A4LD UPDATE HANDBOOK INDEX

FORD A4LD

"UPDATE HANDBOOK"

Figure 48

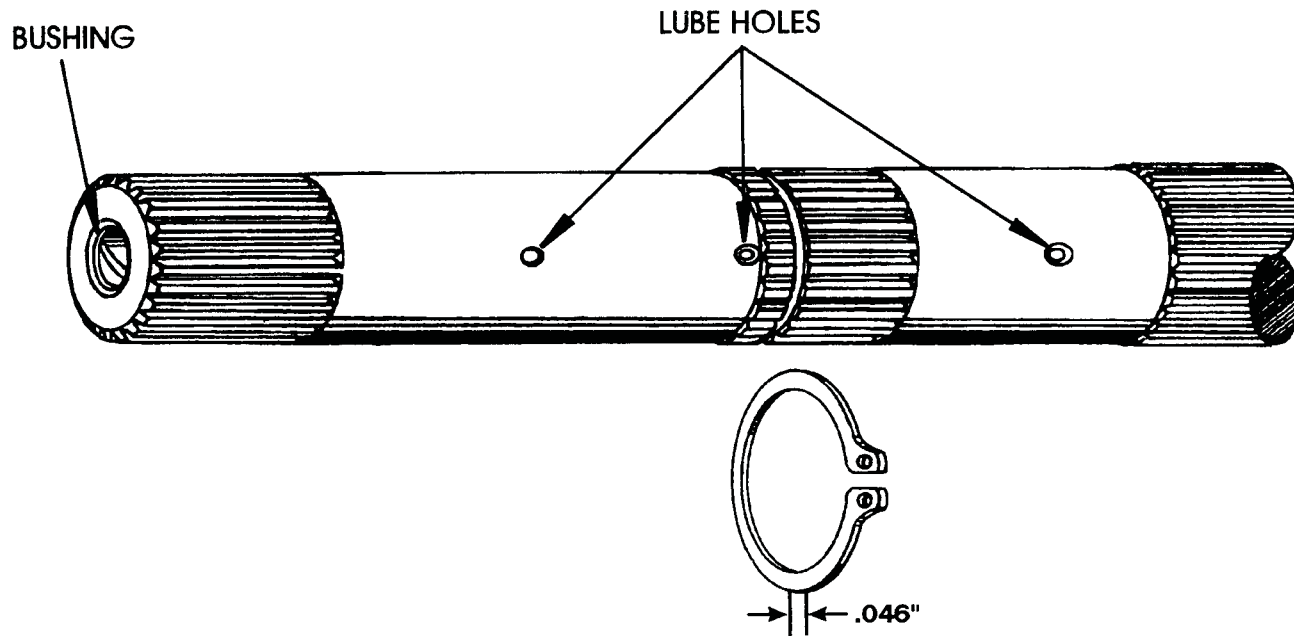
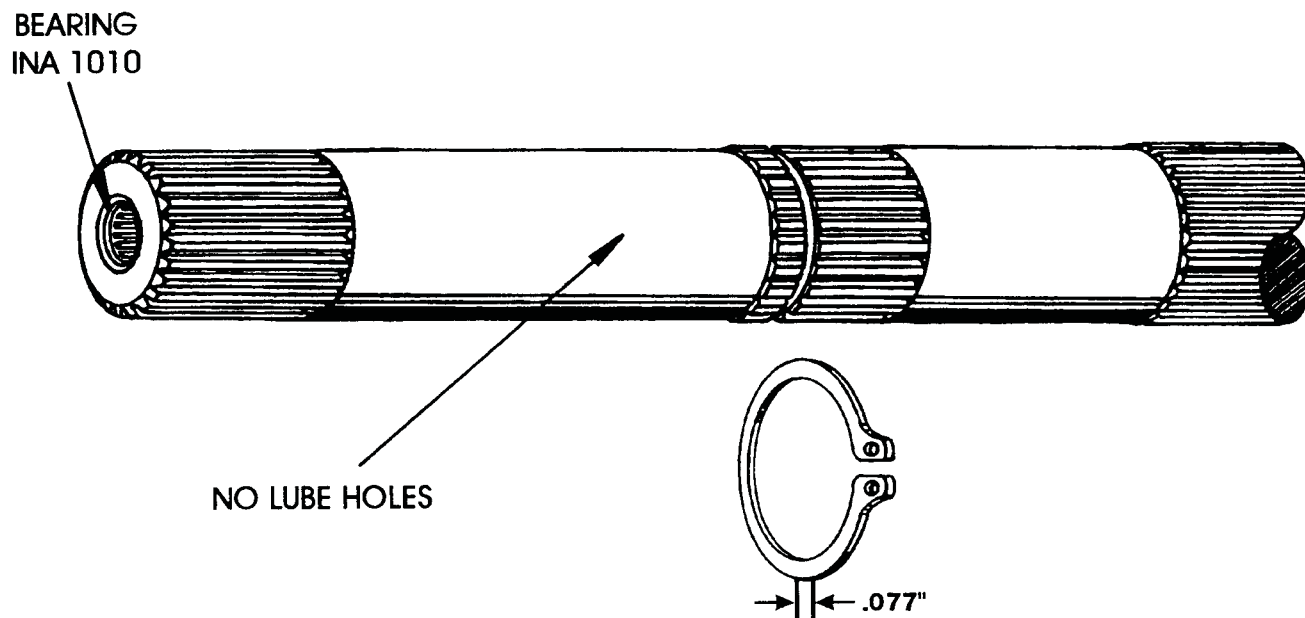
- (8) OUTPUT SHAFT - The Output Shaft was revised in three areas:
- The front output shaft bushing was replaced with a caged needle bearing (See Figure 48).

- The output shaft snap ring groove was machined approximately .030" wider to make room for a revised thickness snap ring (See Figure 48). The new snap ring thickness is .077", as shown in Figure 48.

- The lube holes in the 1st design output shaft were eliminated entirely, to accommodate the revisions in the lube circuit on the 4.0L engine models (See Figure 48).

- (9) OUTPUT SHAFT SNAP RING - The snap ring that retains the rear ring gear and hub onto the output shaft on 4.0L models was increased in thickness, and now measures .077" thick. On all other applications the snap ring measures .046" thick (See Figure 48).

Figure 49

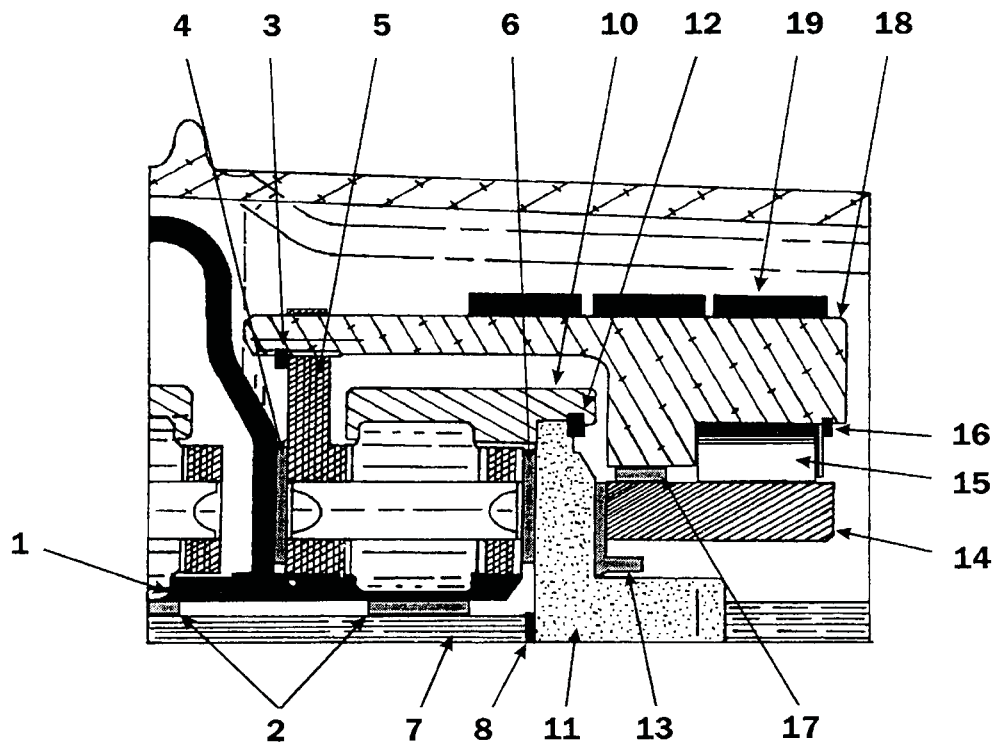
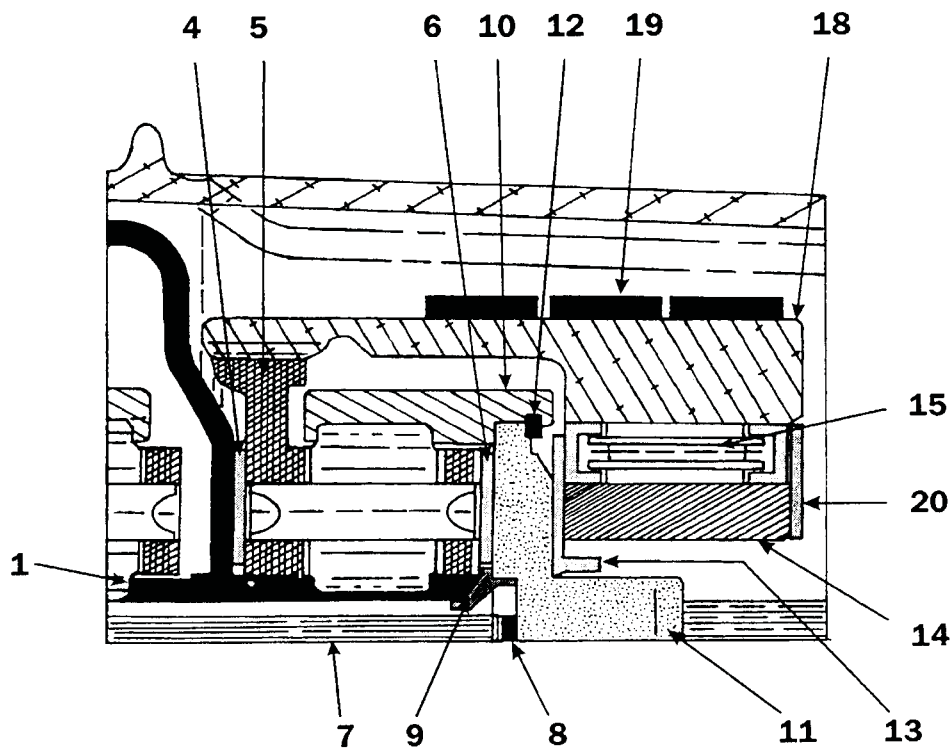
- (6) NUMBER 10 THRUST WASHER - Received a change in outside diameter (See Figure 47), and is now used to retain the low sprag end bearing on 4.0L engine models. Refer to the cutaway illustrations in Figure 49.
The outside diameter on the number 10 thrust washer for the 4 pinion carrier is 2.275", and the outside diameter on the number 10 thrust washer for the 6 pinion carrier is 3.205", as shown in Figure 47.

- (10) REVERSE DRUM SNAP RING - The snap ring that retains the 10 lug (4 Pinion) rear carrier in the Reverse Drum was eliminated on the "Multiple Lug" (6 Pinion) rear carrier for the 4.0L engine models (See Figure 49).

Figure 66

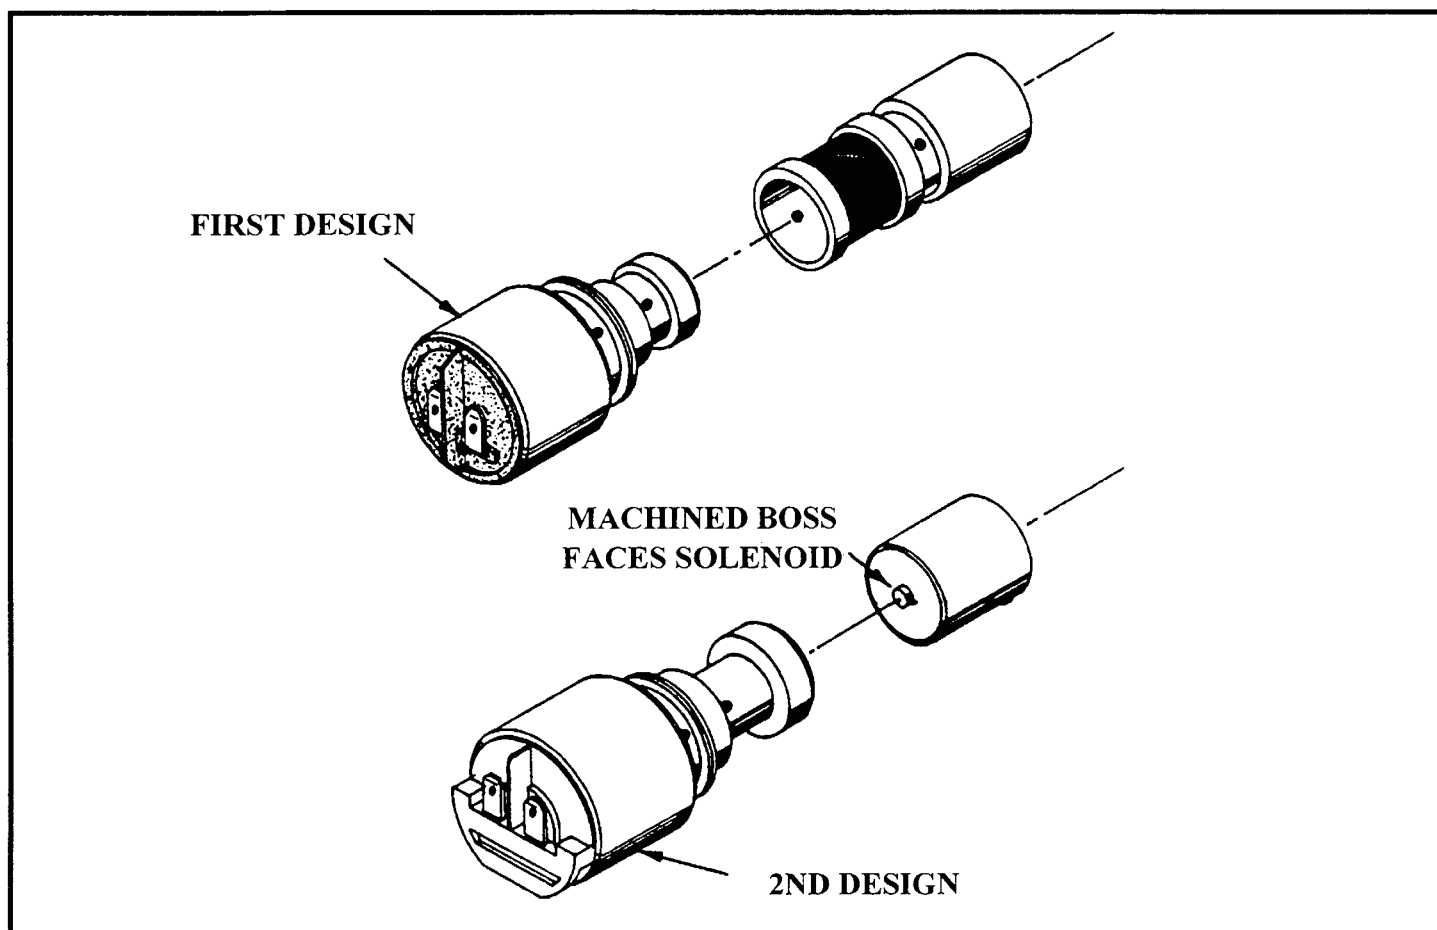
CHANGE: 3-4 shift solenoid was redesigned.

3-4 SHIFT SOLENOID - The 2nd design 3-4 shift solenoid eliminates the screen, has dimensional changes on the solenoid itself, and includes a new plug with a boss machined on one end. The plug must be installed with the machined boss facing the solenoid as shown in Figure 66.

2nd Design Solenoid.....E8TZ-7M107-A

Figure 69

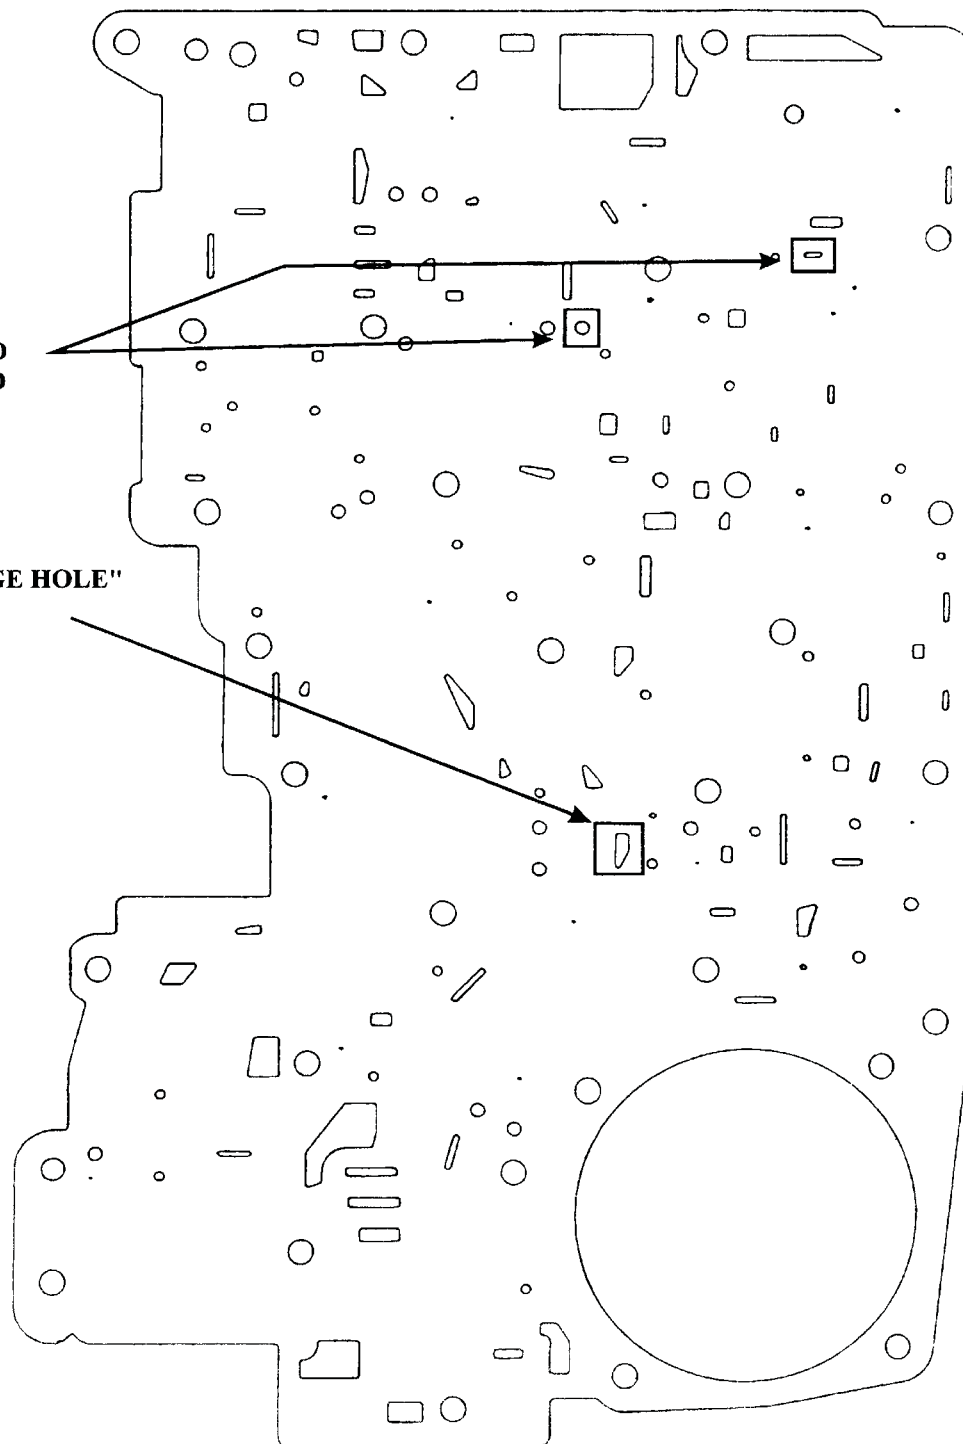
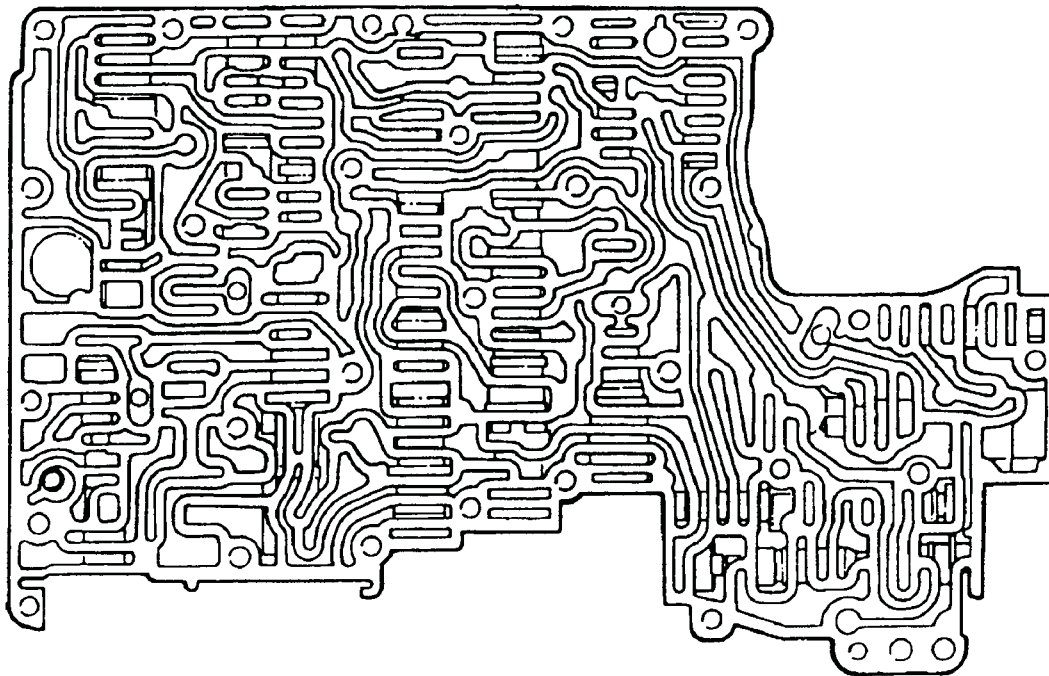
The 2nd design valve train has eliminated two springs and incorporated two spool valves into one, as shown in Figure 69. Figure 70 shows the "Small Hole" spacer plate that is required with the 2nd design line-up in bore 211.

Figure 73

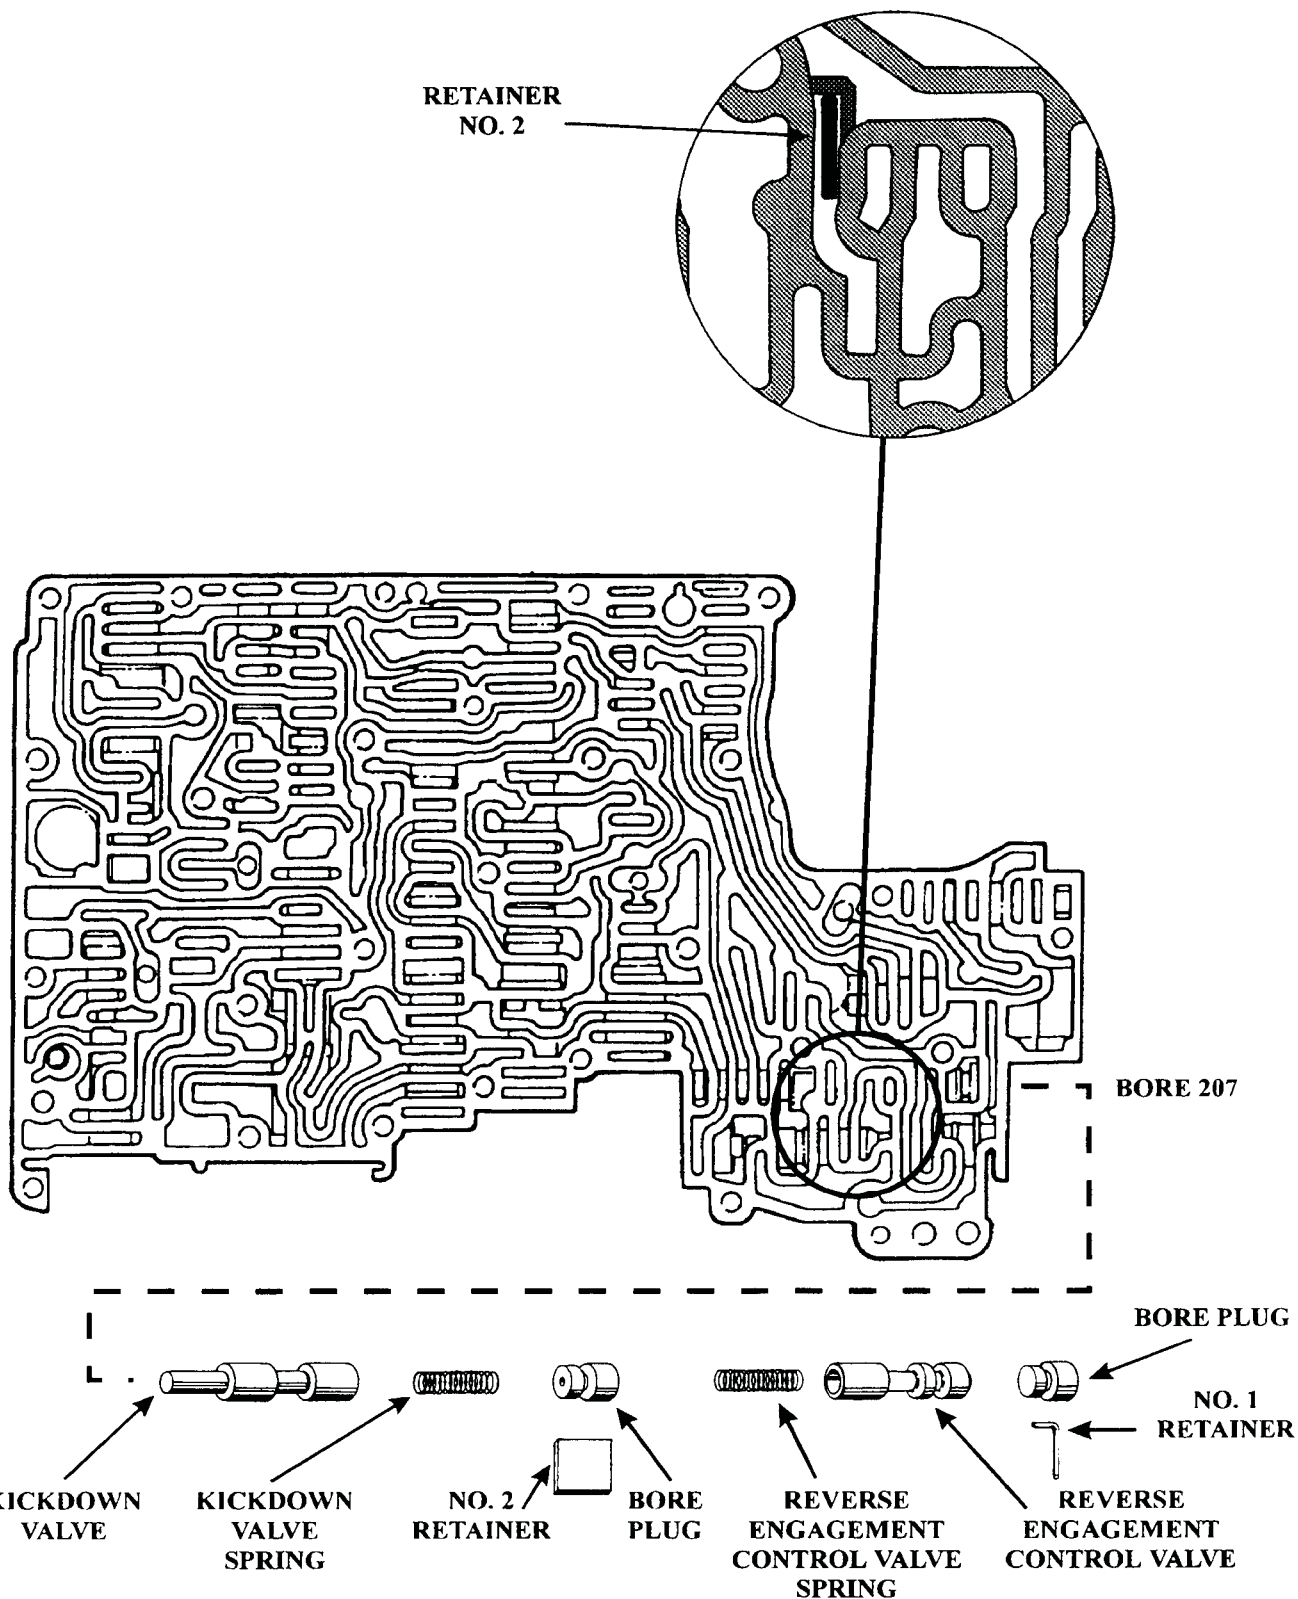
This is when the reverse engagement control valve was added to bore 207, as shown in Figure 73, and also shows the location of the No. 2 retainer in the valve body casting and the direction of the bore plugs. Figure 74 shows the "3 Hole" spacer plate that is required on valve bodies containing the reverse engagement control valve.

Figure 76

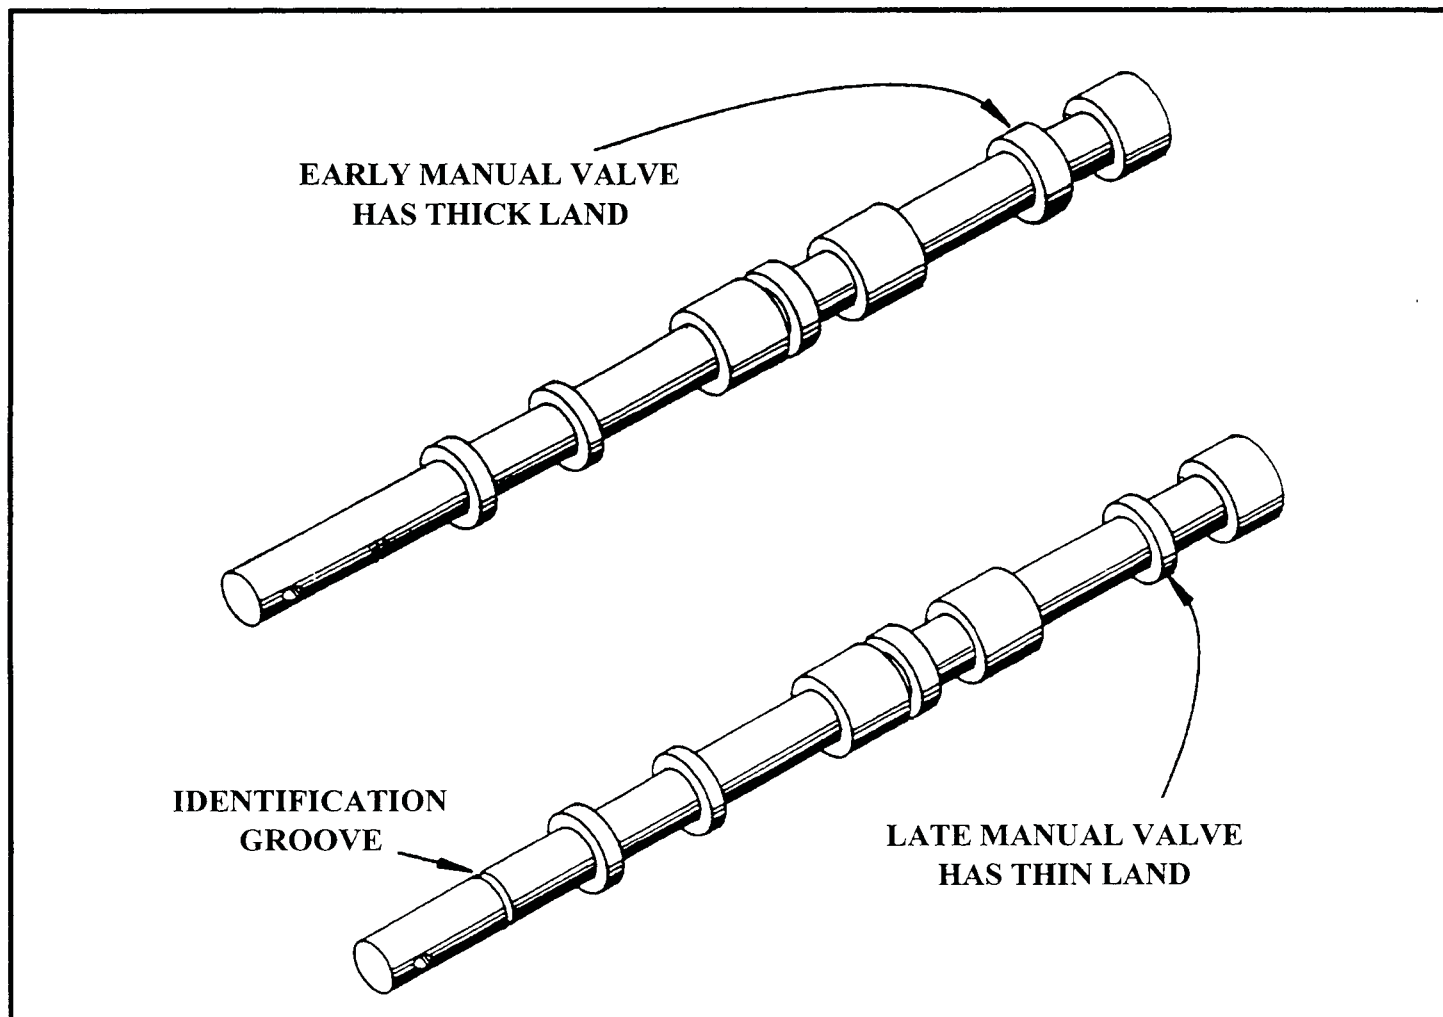
CHANGE: In model year 1988 the manual valve was redesigned.

MANUAL VALVE - The 2nd design manual valve has a thinner land on it as shown in Figure 76, and is identified by a groove just behind the manual valve link hole.

Manual Valve (2nd Design)..... E8TZ-7C389-A
